Service description

Product: TK105	Service description no: 3311-S001	Ver: 1
-------------------	-----------------------------------------	-----------

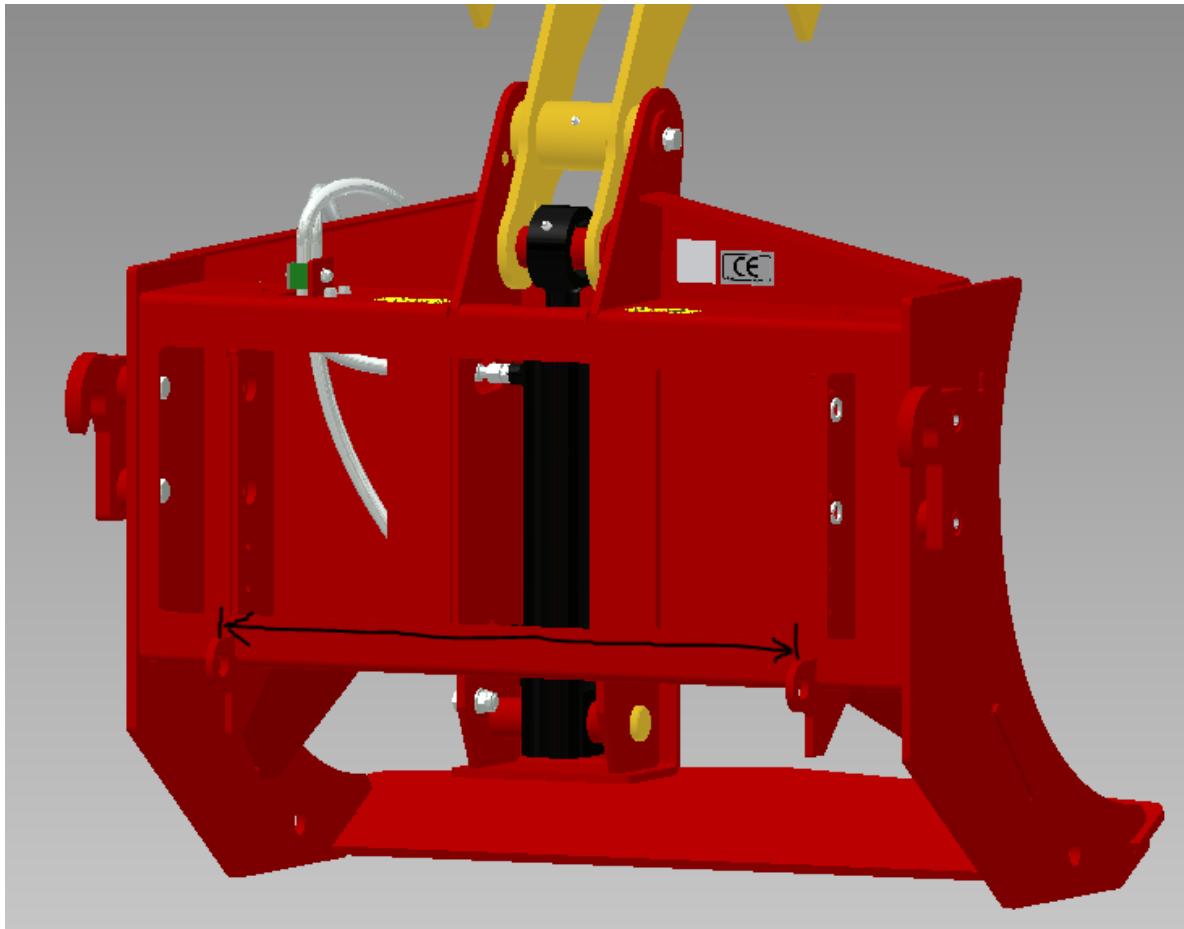
Euro attachment on the claw does not fit on the Lasterramma.

1. The loader has a clean Euro attachment. The distance between locking brackets at the bottom of the claw is too small.
2. The loader has a combined frame with Euro, Trima and Ölø. Euro attachment mounting brackets have too short distance between them.

1. Applies to Timber claw with serial numbers up to 150121.
Cut off the attached brackets and weld them on in the correct position, or buy a claw with a serial number from 150121.

2. Replace Euro attachment with a new type of bracket which expands to the correct distance.
